Car Stereo
Service Bulletin

Model: XM-3040/-3520

No. 200R1

Subject: Protection Turns On

XM-3040

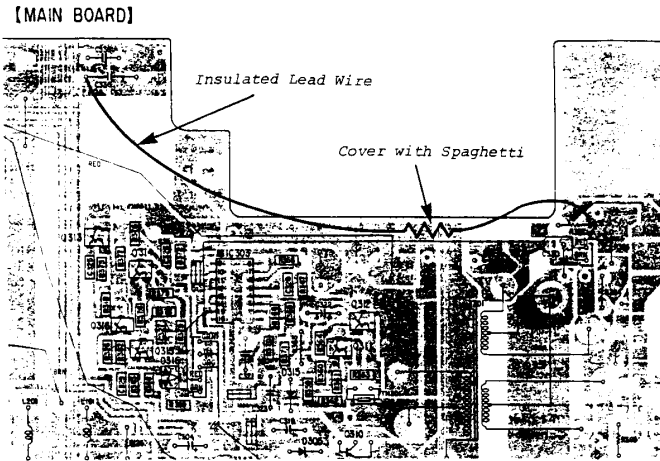
The Protection Circuit is activated when the amplifier is connected to other equipment or when it is tested alone.

Solution: Add the following resistor between the two grounds on the "Main" Board as shown below:

Description	Part Number
470 Ohms 1 W resistor	1-215-867-00
